# NEXTDC S4

# STATE SIGNIFICANT DEVELOPMENT APPLICATION (SSDA) SUBMISSION

**SSDA MODIFICATION TO THE APPROVED SSDA (SSD-63741210):**

1 **SSDA GENERAL ARRANGEMENT OVERALL PLAN - GROUND FLOOR**
1 : 500

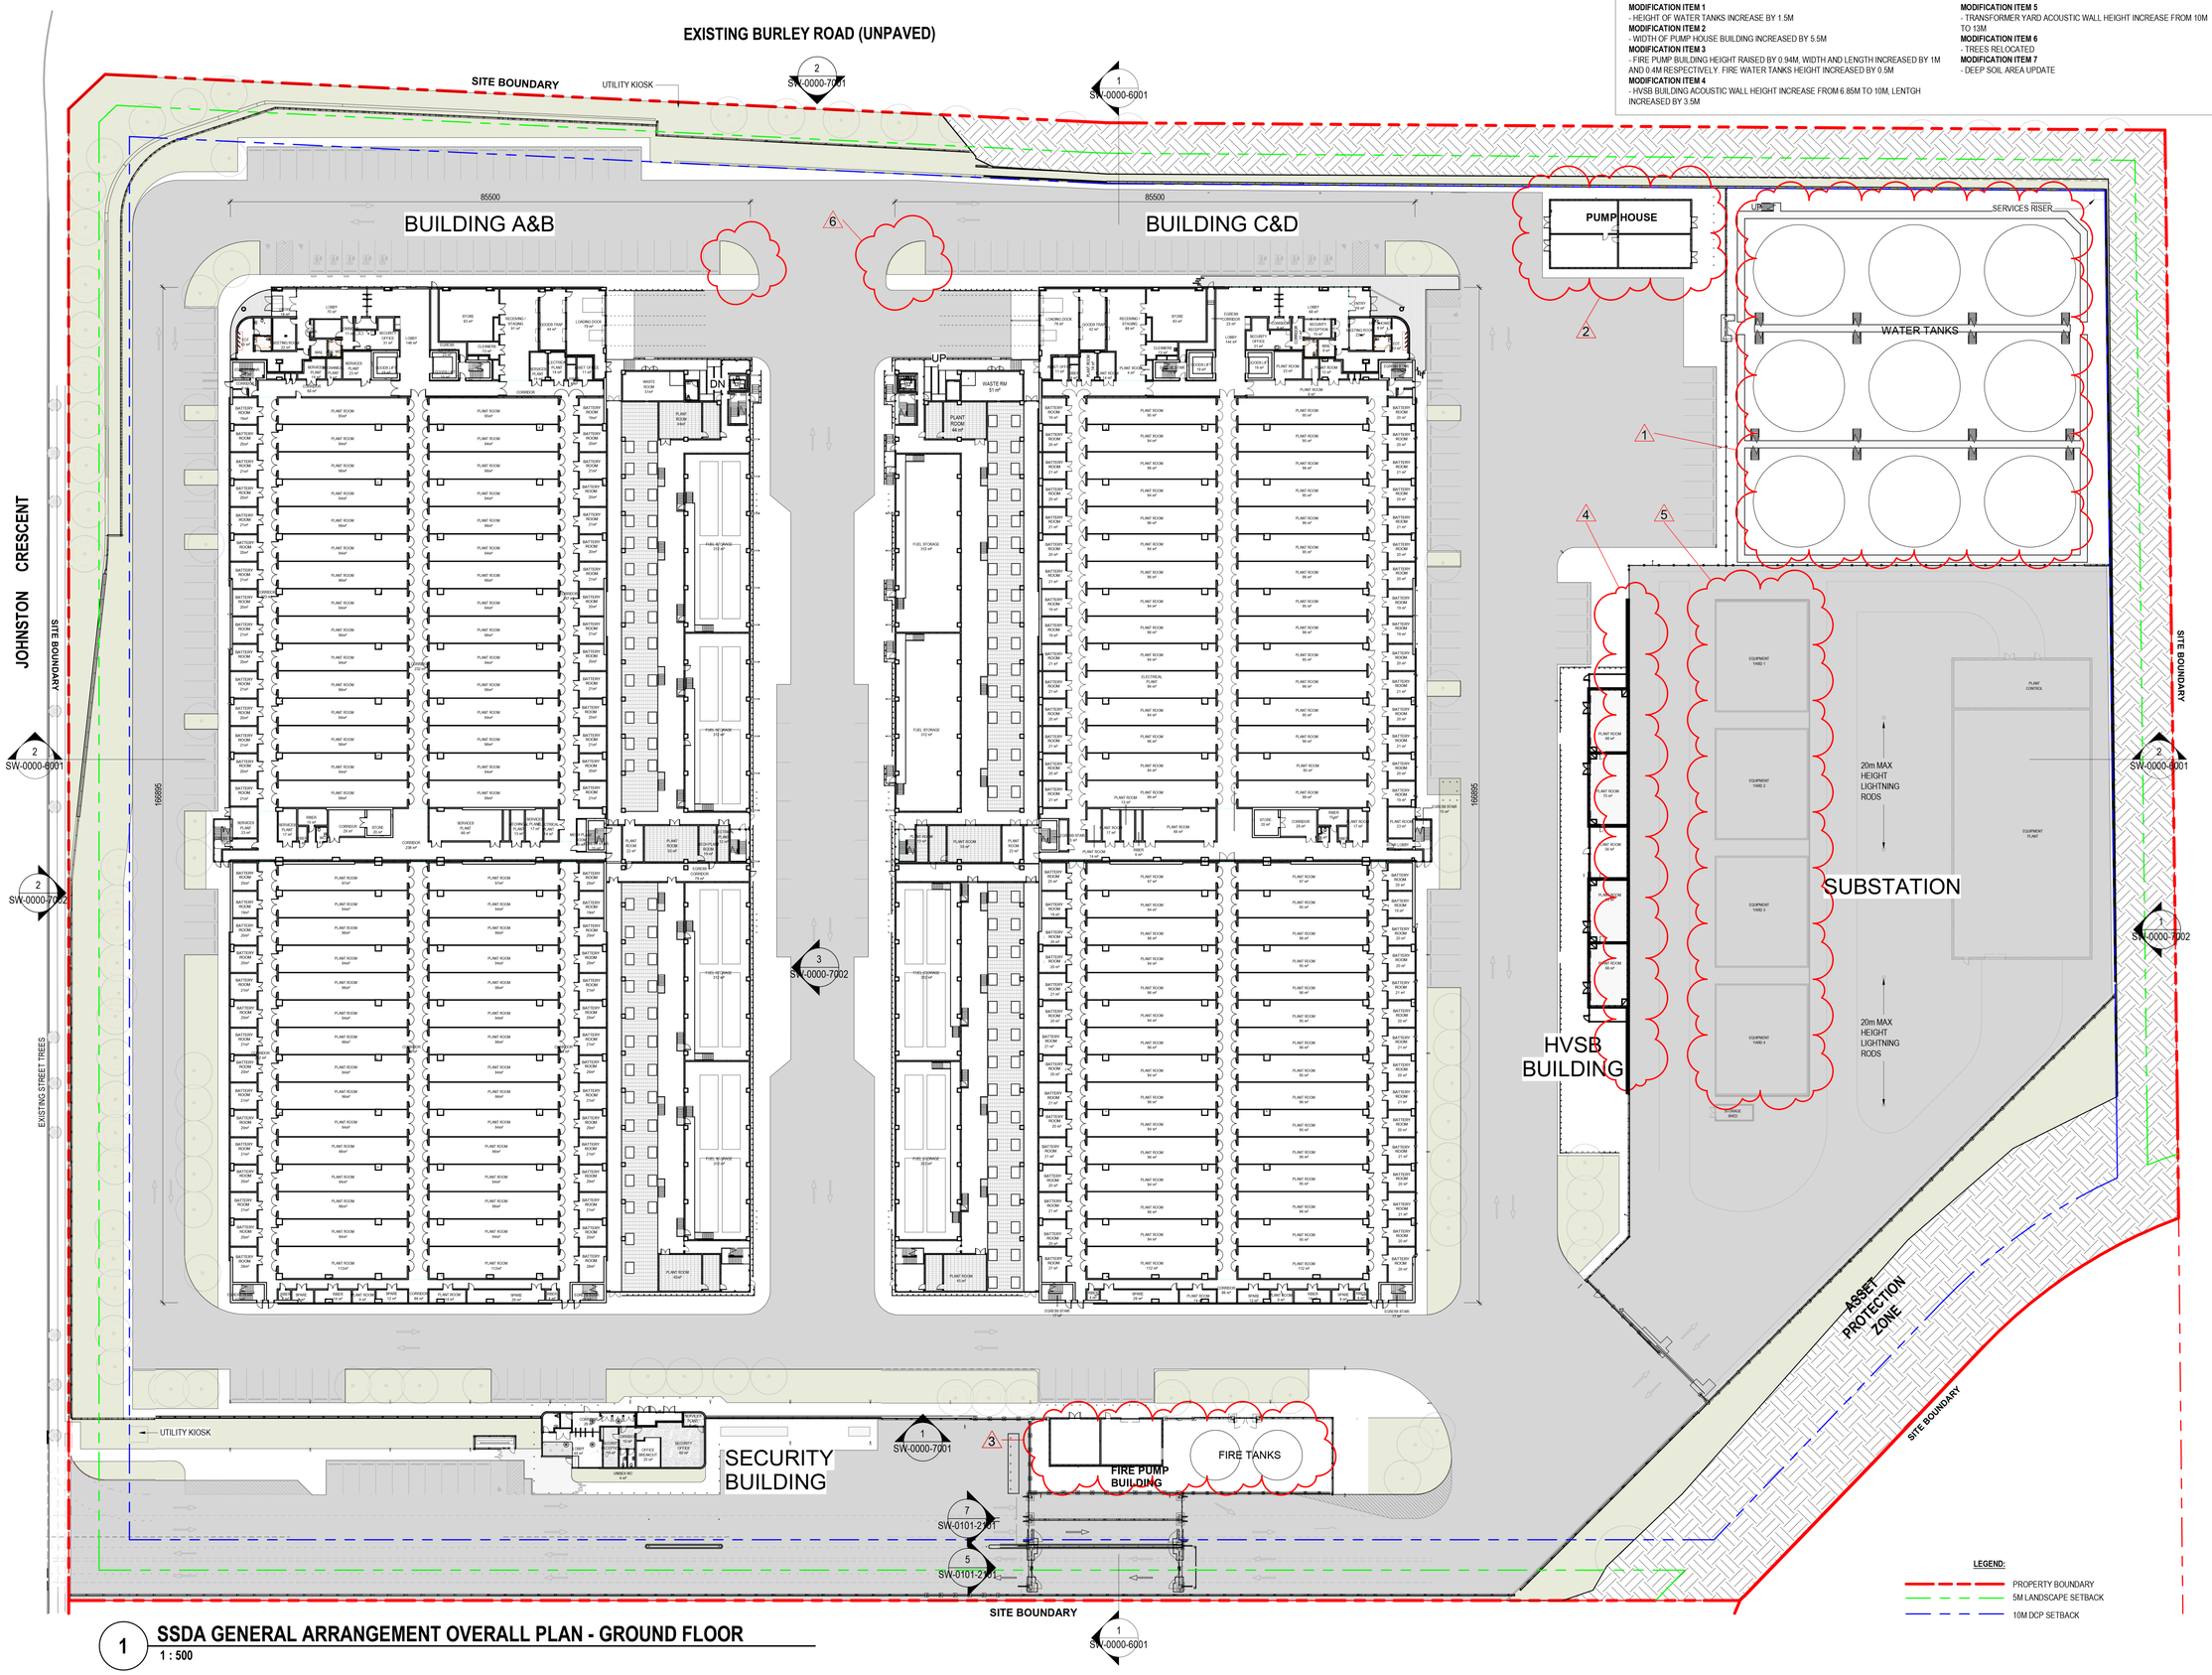
**MODIFICATION ITEM 1**
- HEIGHT OF WATER TANKS INCREASE BY 1.5M

**MODIFICATION ITEM 2**
- WIDTH OF PUMP HOUSE BUILDING INCREASED BY 5.5M

**MODIFICATION ITEM 3**
- FIRE PUMP BUILDING HEIGHT RAISED BY 0.94M, WIDTH AND LENGTH INCREASED BY 1M AND 0.4M RESPECTIVELY. FIRE WATER TANKS HEIGHT INCREASED BY 0.5M

**MODIFICATION ITEM 4**
- HVSB BUILDING ACOUSTIC WALL HEIGHT INCREASE FROM 6.85M TO 10M, LENTGH INCREASED BY 3.5M

**MODIFICATION ITEM 5**
- TRANSFORMER YARD ACOUSTIC WALL HEIGHT INCREASE FROM 10M TO 13M

**MODIFICATION ITEM 6**
- TREES RELOCATED

**MODIFICATION ITEM 7**
- DEEP SOIL AREA UPDATE

Drawing Title
SITE WIDE
SSDA GA OVERALL SECTIONS

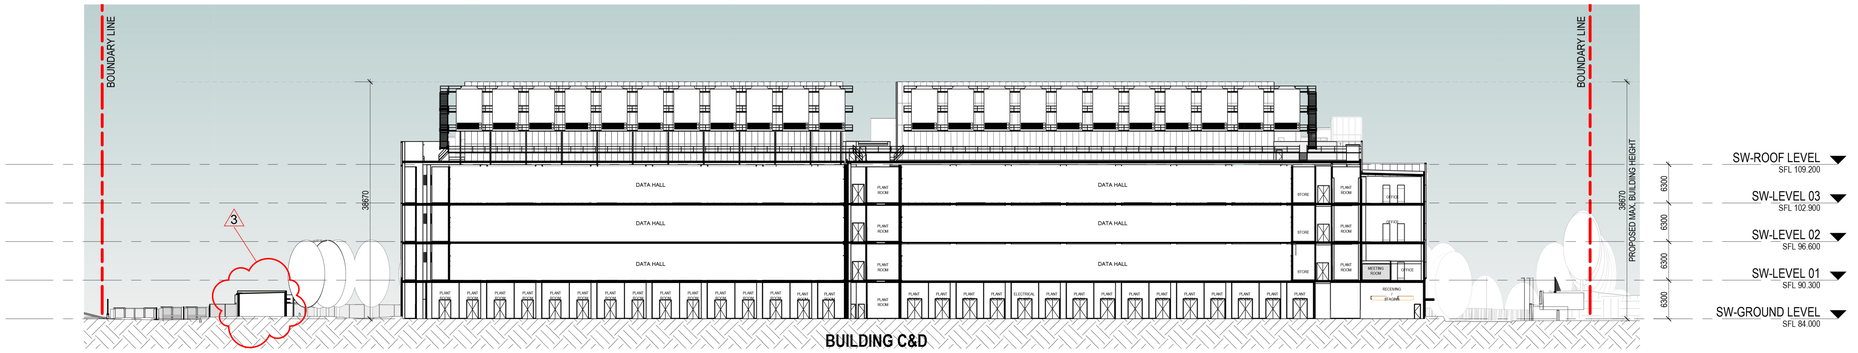
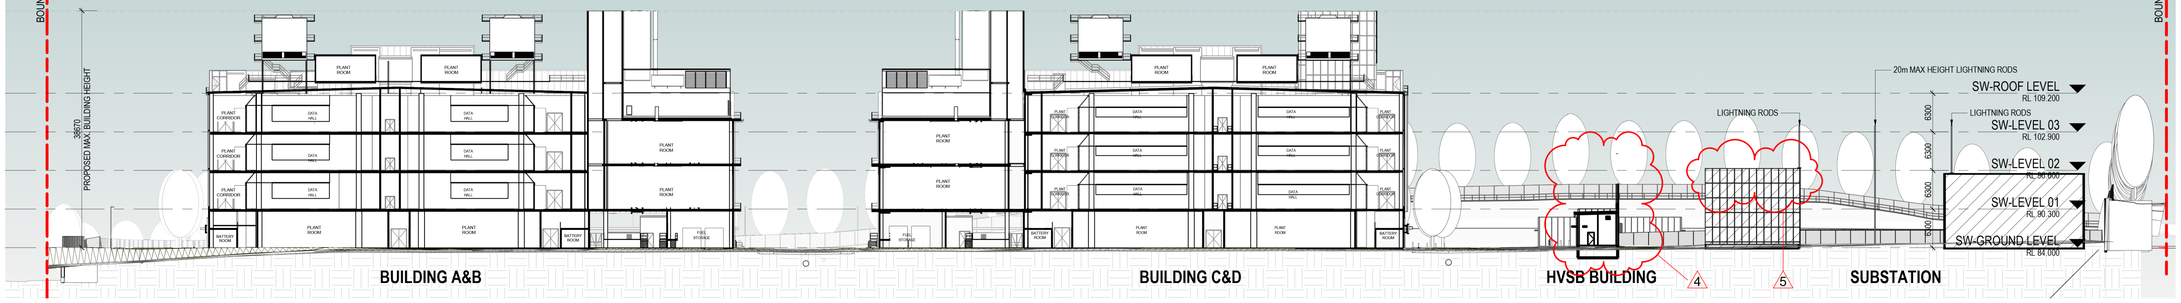
**MODIFICATION ITEM 1**
- HEIGHT OF WATER TANKS INCREASE BY 1.5M

**MODIFICATION ITEM 2**
- WIDTH OF PUMP HOUSE BUILDING INCREASED BY 5.5M

**MODIFICATION ITEM 3**
- FIRE PUMP BUILDING HEIGHT RAISED BY 0.94M, WIDTH AND LENGTH INCREASED BY 1M AND 0.4M RESPECTIVELY. FIRE WATER TANKS HEIGHT INCREASED BY 0.5M

**MODIFICATION ITEM 4**
- HVSB BUILDING ACOUSTIC WALL HEIGHT INCREASE FROM 6.85M TO 10M, LENTGH INCREASED BY 3.5M

**MODIFICATION ITEM 5**
- TRANSFORMER YARD ACOUSTIC WALL HEIGHT INCREASE FROM 10M TO 13M

**MODIFICATION ITEM 6**
- TREES RELOCATED

**MODIFICATION ITEM 7**
- DEEP SOIL AREA UPDATE

Drawing Title: SITE WIDE
SSDA GA OVERALL ELEVATIONS - SHEET 1

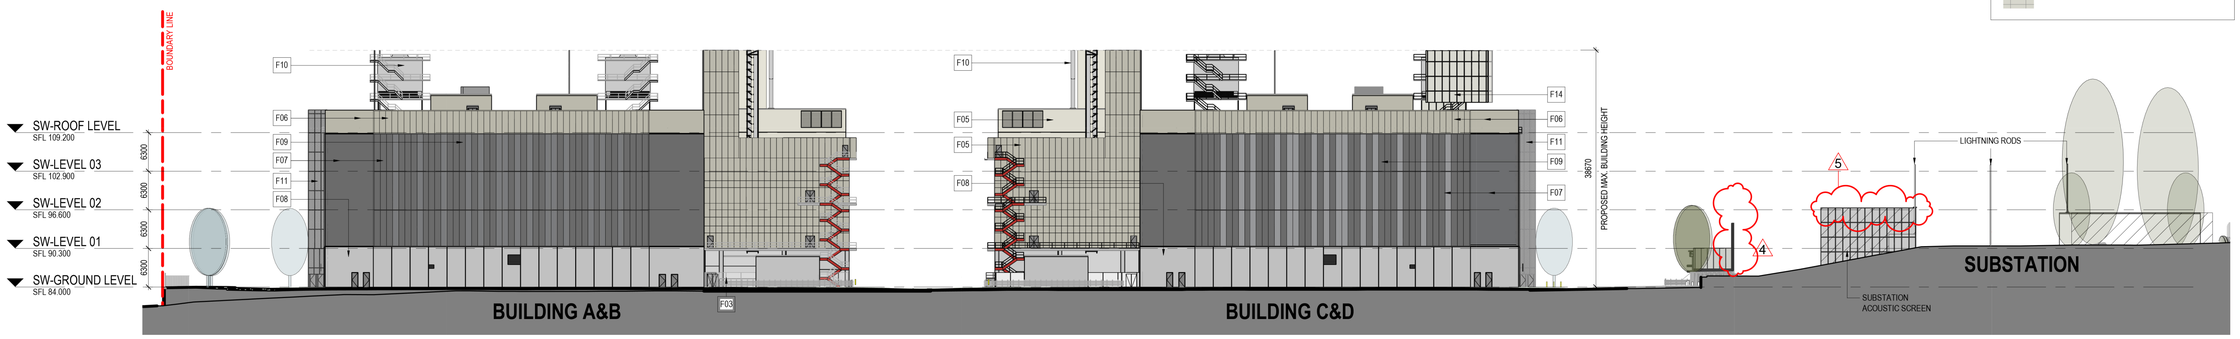
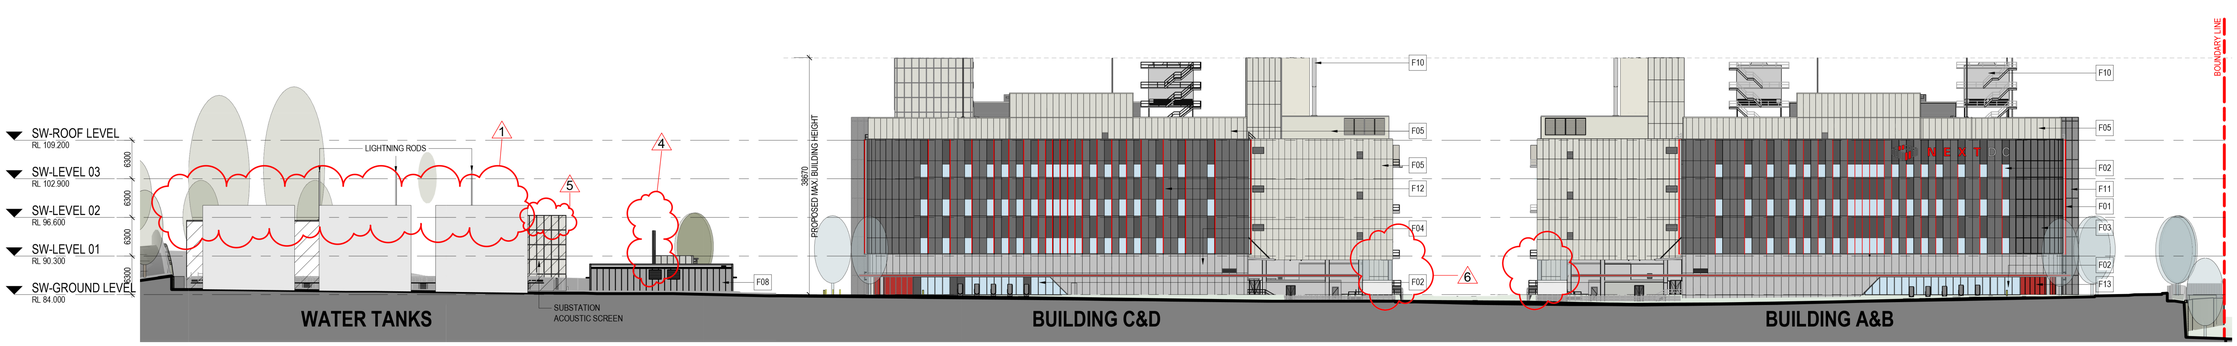
**MODIFICATION ITEM 1**
- HEIGHT OF WATER TANKS INCREASE BY 1.5M

**MODIFICATION ITEM 2**
- WIDTH OF PUMP HOUSE BUILDING INCREASED BY 5.5M

**MODIFICATION ITEM 3**
- FIRE PUMP BUILDING HEIGHT RAISED BY 0.94M, WIDTH AND LENGTH INCREASED BY 1M AND 0.4M RESPECTIVELY. FIRE WATER TANKS HEIGHT INCREASED BY 0.5M

**MODIFICATION ITEM 4**
- HVSB BUILDING ACOUSTIC WALL HEIGHT INCREASE FROM 6.85M TO 10M, LENTGH INCREASED BY 3.5M

**MODIFICATION ITEM 5**
- TRANSFORMER YARD ACOUSTIC WALL HEIGHT INCREASE FROM 10M TO 13M

**MODIFICATION ITEM 6**
- TREES RELOCATED

**MODIFICATION ITEM 7**
- DEEP SOIL AREA UPDATE

Drawing Title: SITE WIDE
SSDA GA OVERALL ELEVATIONS - SHEET 2

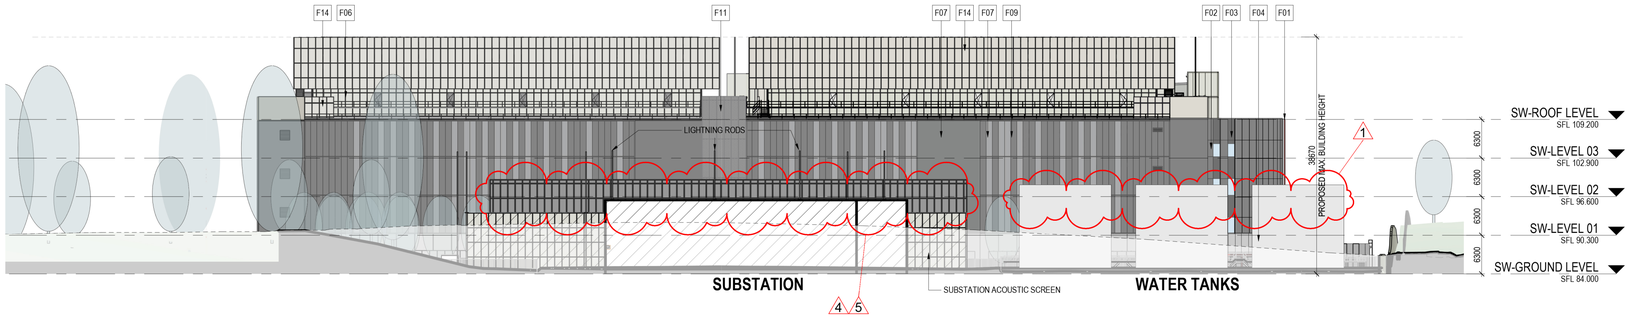
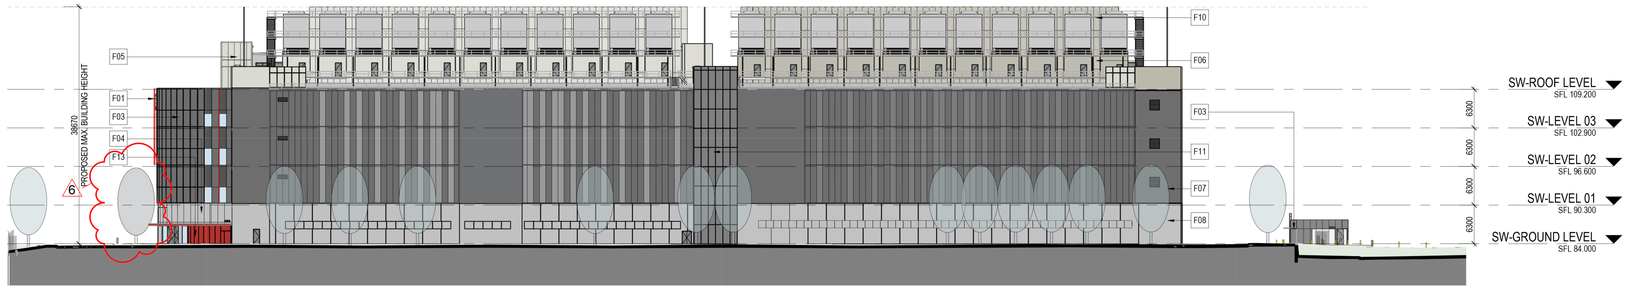
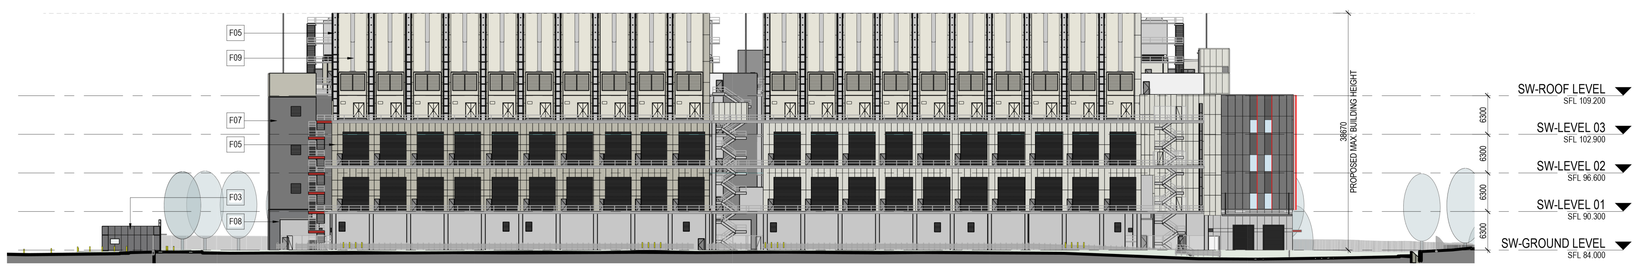
**MODIFICATION ITEM 1**
- HEIGHT OF WATER TANKS INCREASE BY 1.5M

**MODIFICATION ITEM 2**
- WIDTH OF PUMP HOUSE BUILDING INCREASED BY 5.5M

**MODIFICATION ITEM 3**
- FIRE PUMP BUILDING HEIGHT RAISED BY 0.94M, WIDTH AND LENGTH INCREASED BY 1M AND 0.4M RESPECTIVELY. FIRE WATER TANKS HEIGHT INCREASED BY 0.5M

**MODIFICATION ITEM 4**
- HVSB BUILDING ACOUSTIC WALL HEIGHT INCREASE FROM 6.85M TO 10M, LENTGH INCREASED BY 3.5M

**MODIFICATION ITEM 5**
- TRANSFORMER YARD ACOUSTIC WALL HEIGHT INCREASE FROM 10M TO 13M

**MODIFICATION ITEM 6**
- TREES RELOCATED

**MODIFICATION ITEM 7**
- DEEP SOIL AREA UPDATE
